Reasons for Decision

Conditional Approval of 2019 Final Closure Plan for Cobble Hill Holdings Landfill

**Re: Leachate Generation Review – Task 4
Review of the Cobble Hill Landfill Updated Final Closure Plan 2019
460 Stebbings Road Near Shawnigan Lake, British Columbia**

RE: Review of Groundwater Information in the Cobble Hill Landfill Closure Plan

Figure 3.1 – Precipitation vs. Leachate Generation

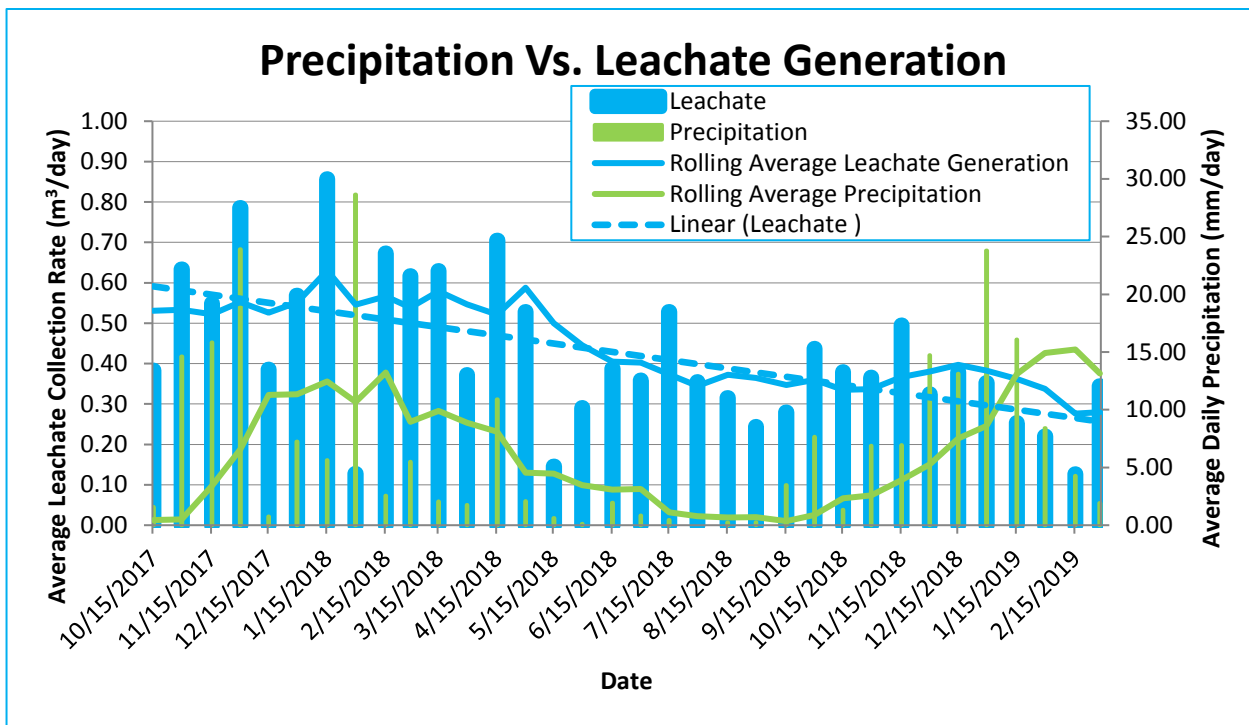
As shown in Figure 3.1 and in the Closure Plan, the leachate generation rate is trending downwards. In general, spikes in the precipitation do not appear to have a strong correlation with increases in leachate generation. There is a period between February 2018 and September 2018 where both the precipitation and leachate generation rates are decreasing. However, the leachate generation rate is expected to decrease following closure and precipitation decreases for the summer months. From October 2018 through December 2017, the precipitation increases without a significant increase in leachate generation. Note, also, that the leachate generation rate falls from November 2018 through February 2019, which is the wettest season. This timeframe is also beyond the chart shown in Figure 7-3 in the Closure Report and would support the continuation of the downward trend line presented on that figure. From the data available, there does not appear to be a strong correlation between precipitation and leachate generation. GHD does note that this assessment is based on approximately 16 months of data. The fluctuations in leachate generation illustrated in the graph may be due to the heterogeneity of the waste soil matrix rather than influences from water ingress. A larger data set would facilitate additional trend comparisons between precipitation and leachate generation over multiple seasons. Also note that precipitation that infiltrates into the waste soil mass would need to flow through what is reported to be silty soil, so regardless, any effect of a leak on leachate generation would be muted and likely take months to reach the leachate collection system.

Graph 1 depicts chloride concentrations over time from monitoring well MW2

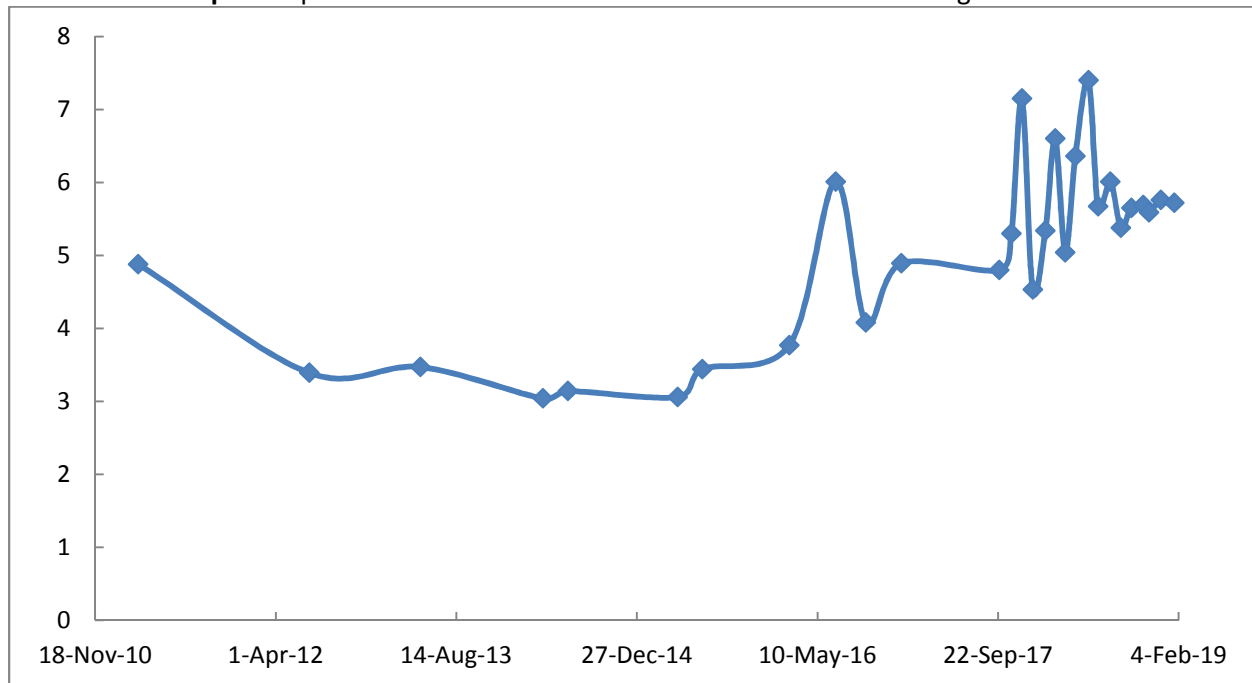
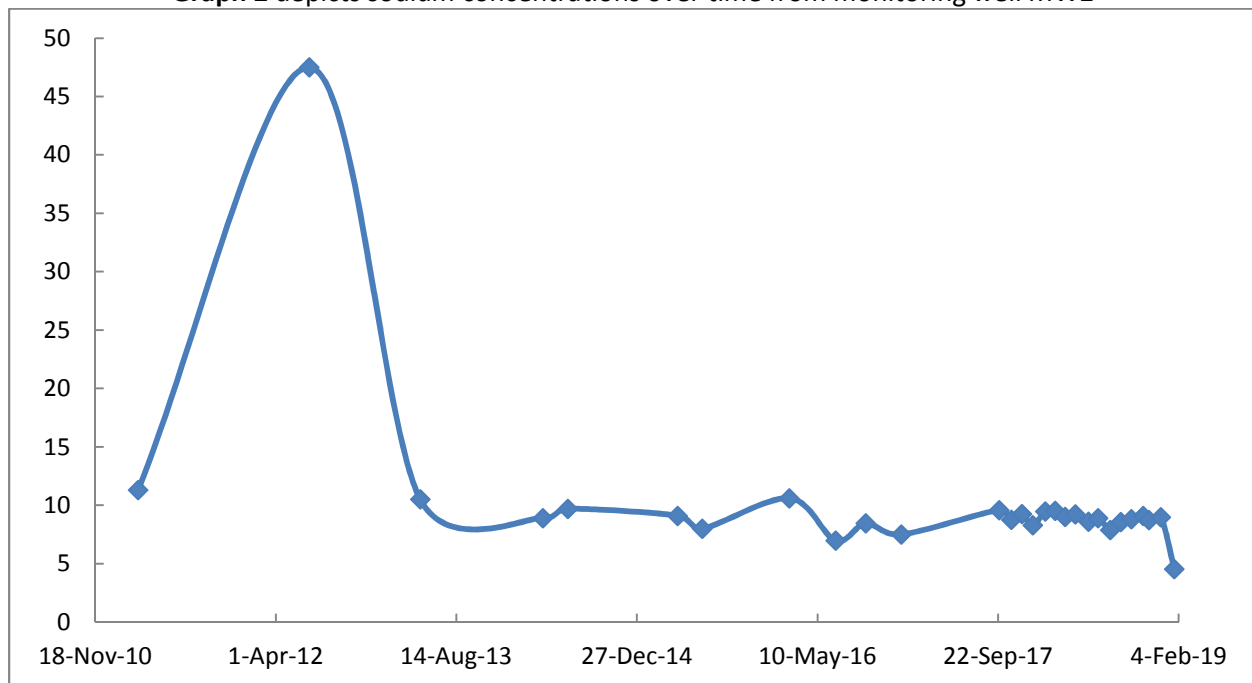
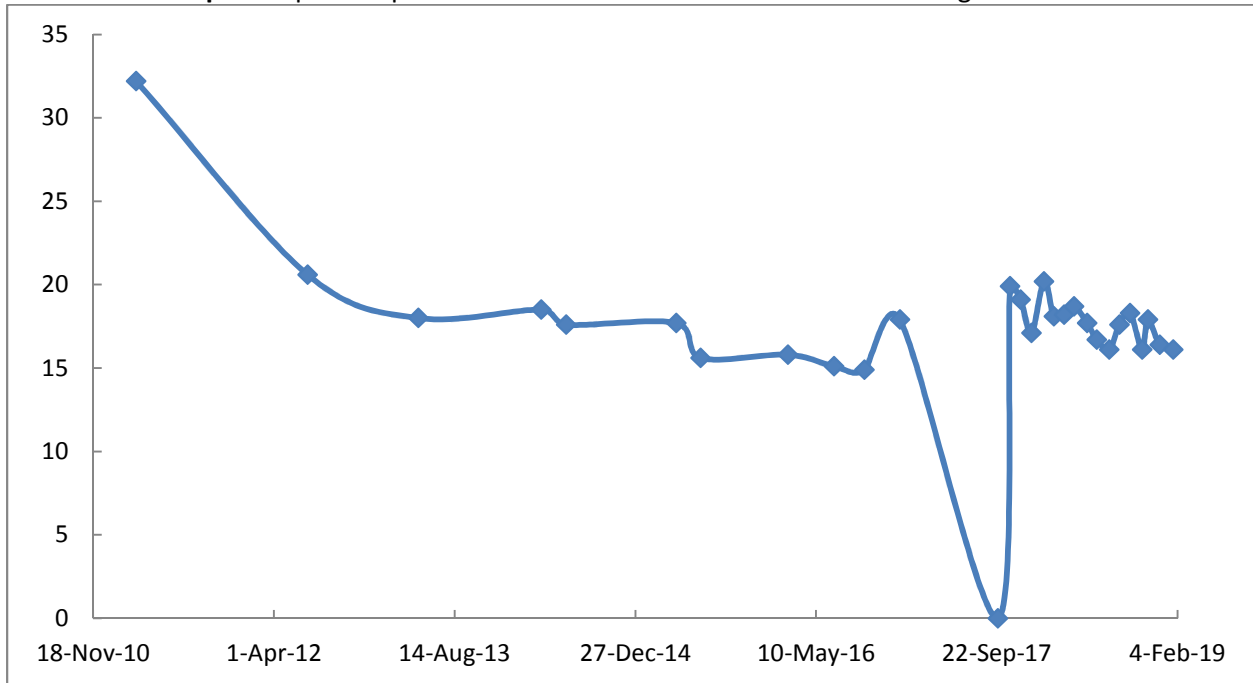
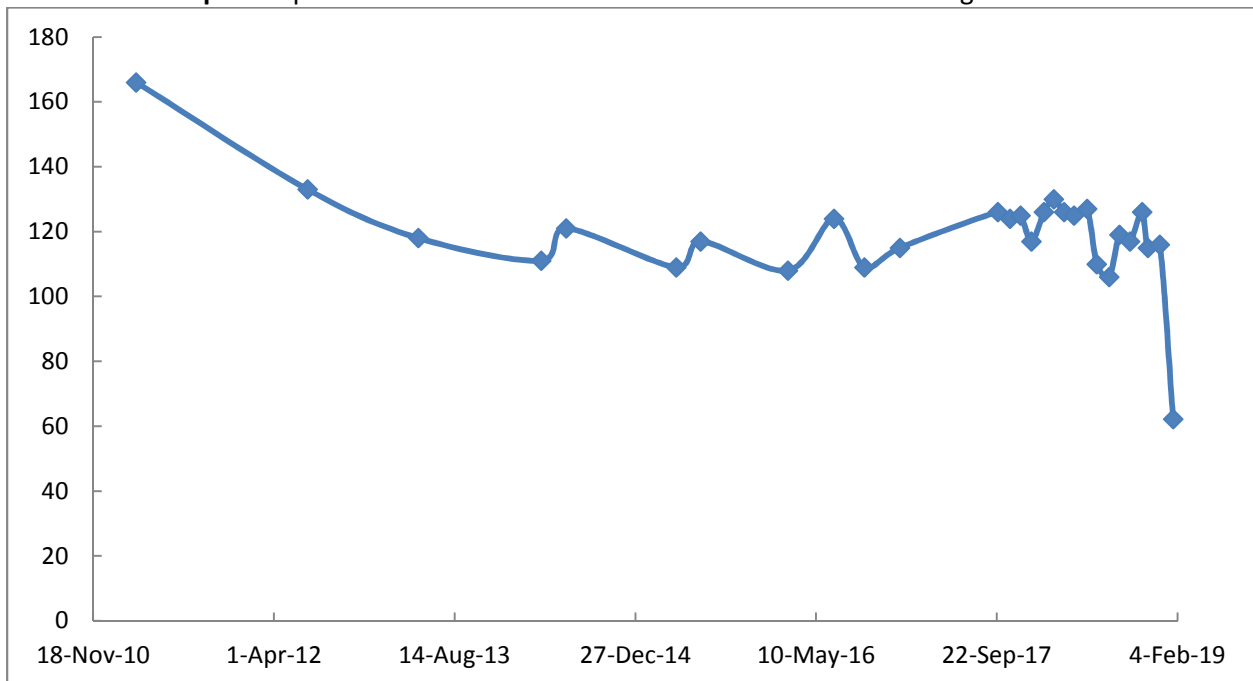
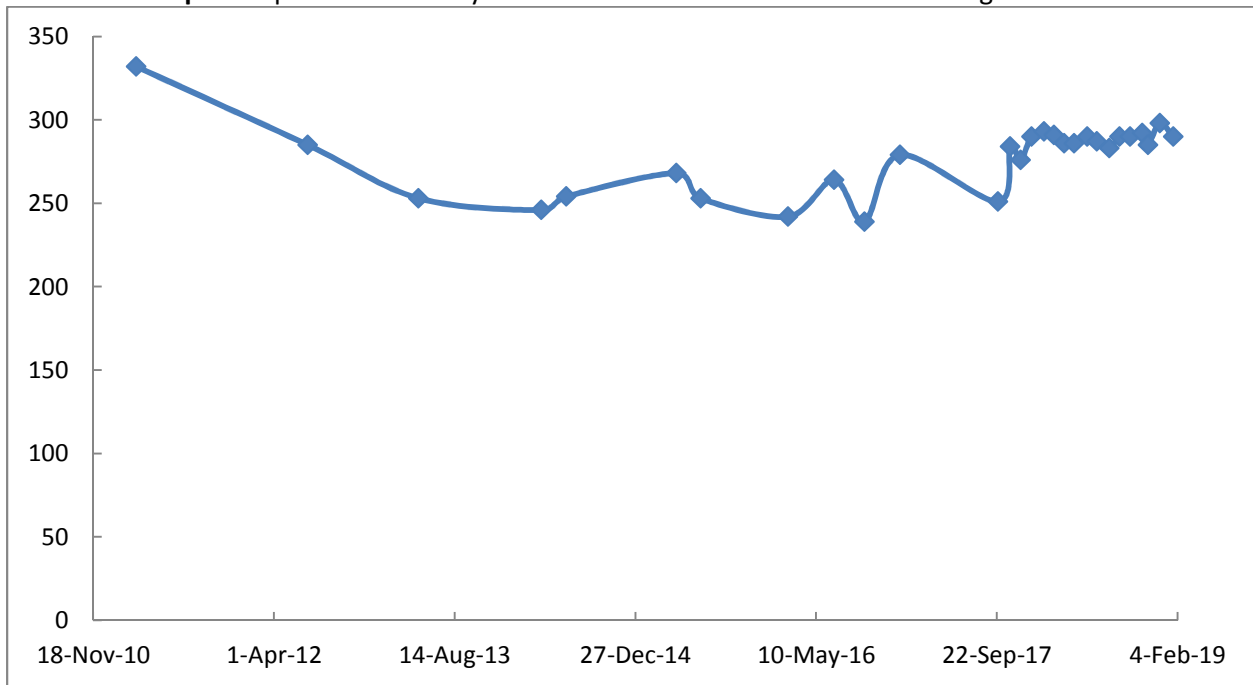
All water quality indicators graphed above are generally stable. The chloride graph may show a minimal upward trend, but additional monitoring is required to confirm this interpretation.

Plot 2 shows the difference between the geochemical character of water from MW2 and leachate

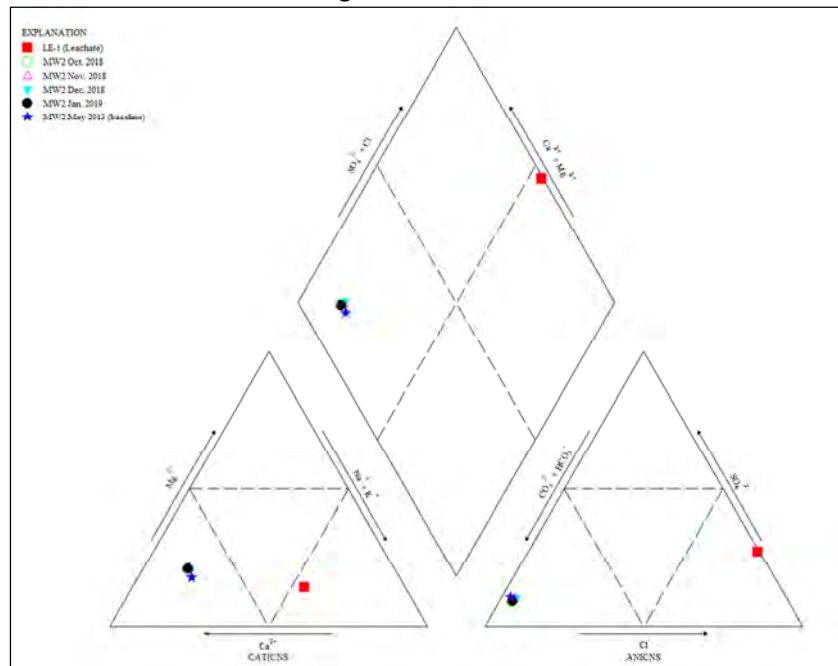
The trilinear diagram presented below indicates that the geochemical character of the recent water quality collected from MW2 is stable and unaffected by leachate. As such, there is no evidence that water quality in monitoring well MW2 is impacted by the landfill.

Graph 6 depicts chloride concentrations over time from monitoring wells MW3S and MW3D

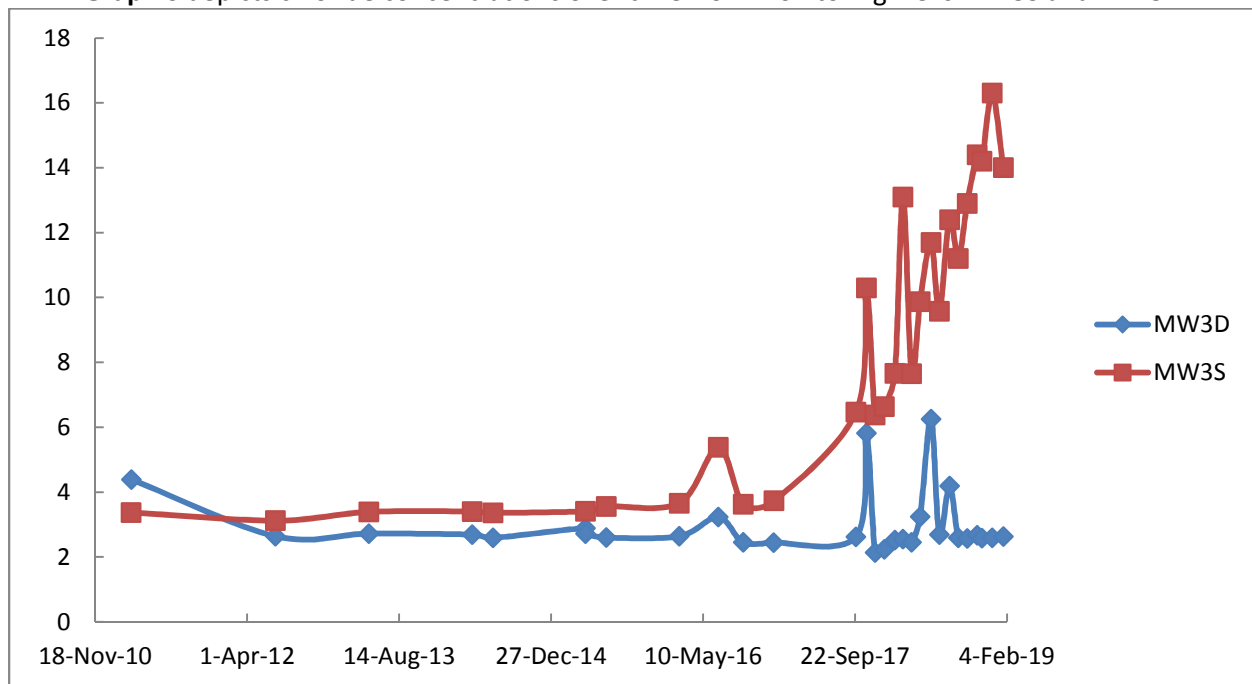
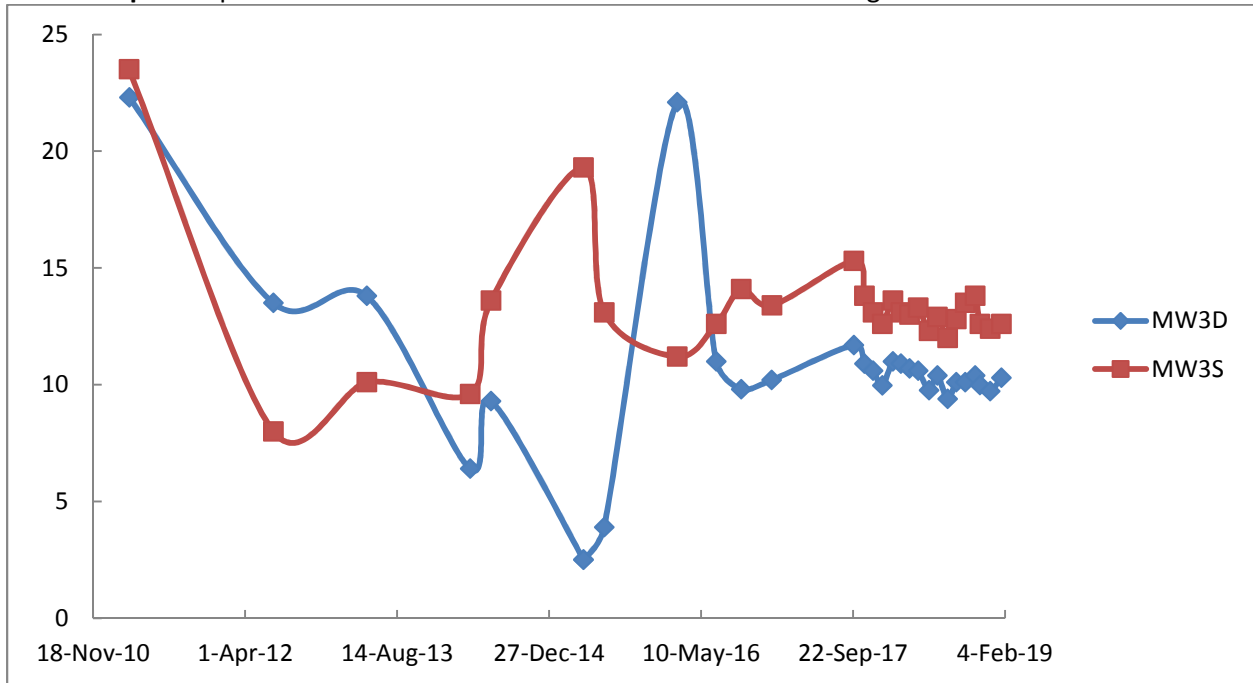
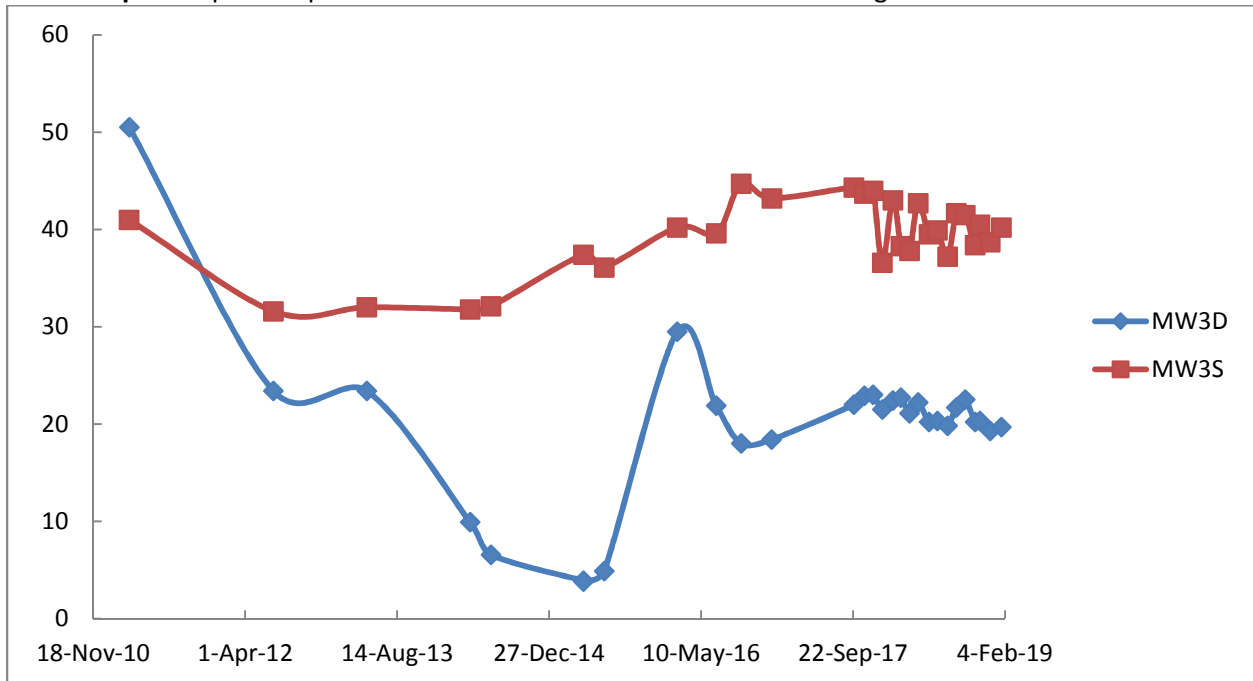
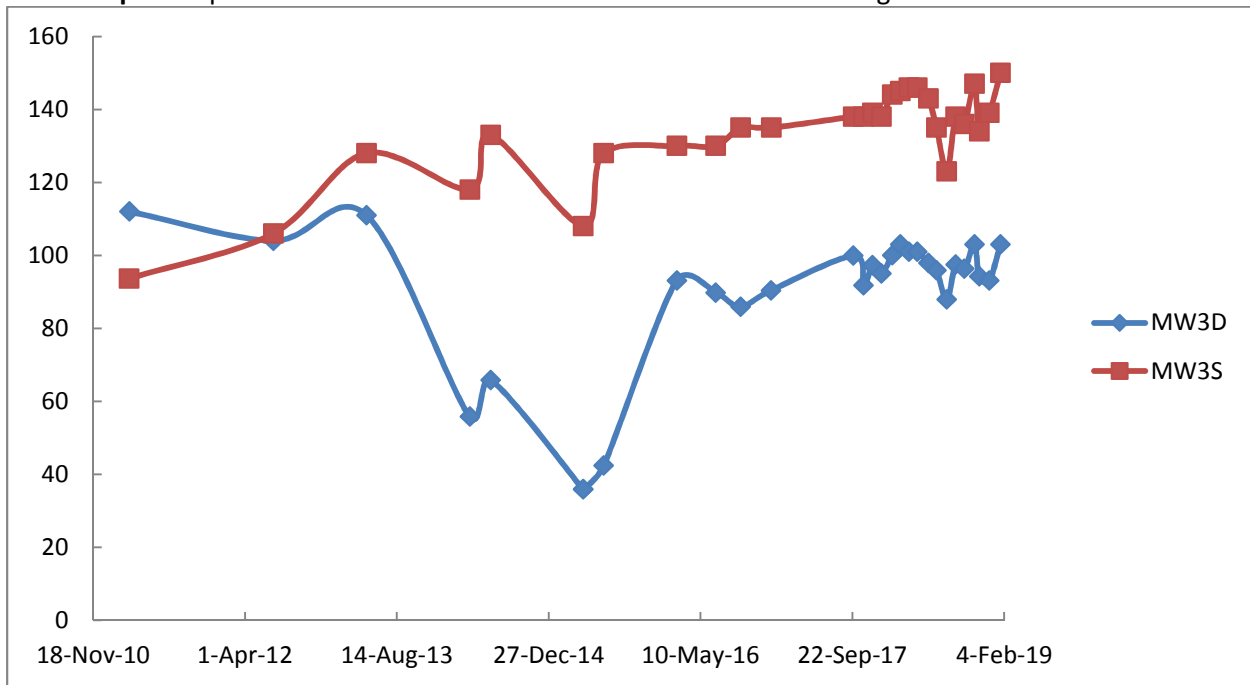
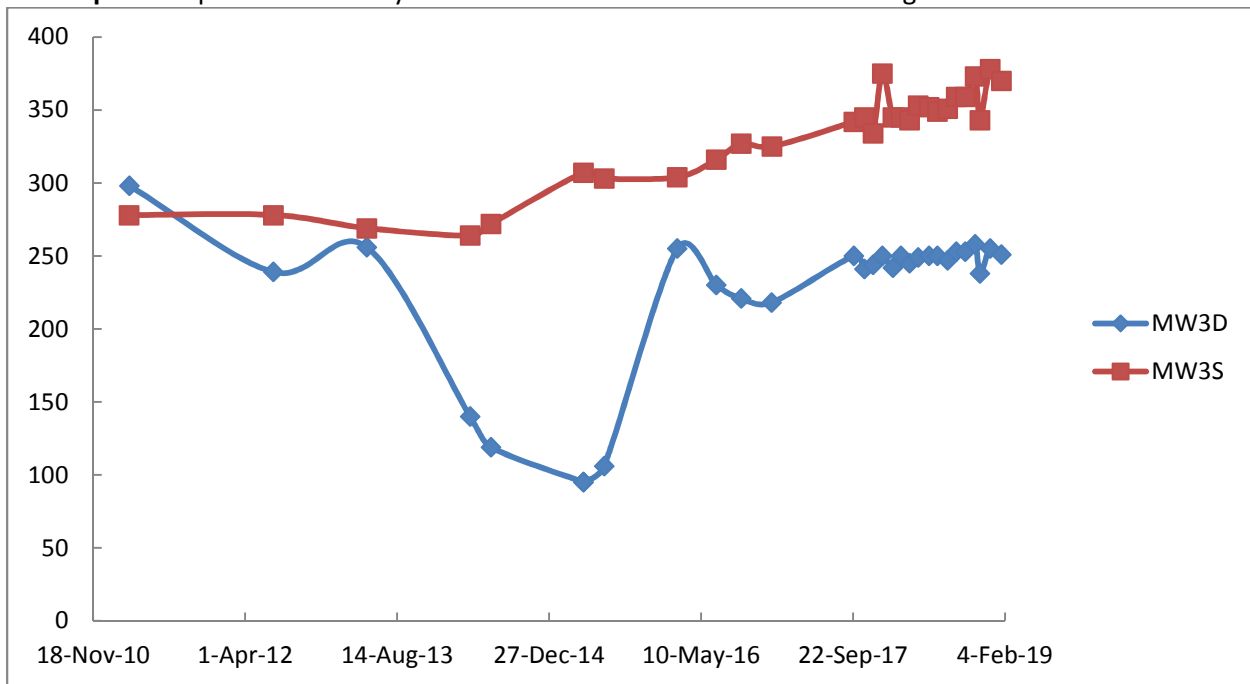
An increasing trend in chloride concentrations is evident in the shallow monitoring well MW3S (Graph 6). Similar but less pronounced trends are observed at MW3S in the electric conductivity and hardness graphs (Graphs 9 and 10). These small increases pose no risk to the environment at this time, since the water quality guideline for chloride is 250 mg/L. The reason for the upward trends is unknown, but the

landfill may be a likely source. However, the trends may not be attributed to the landfill alone or at all. A detailed discussion regarding the small changes in water quality at MW3S is described later in this review. All other indicators at MW3S and all indicators at MW3D are generally stable.
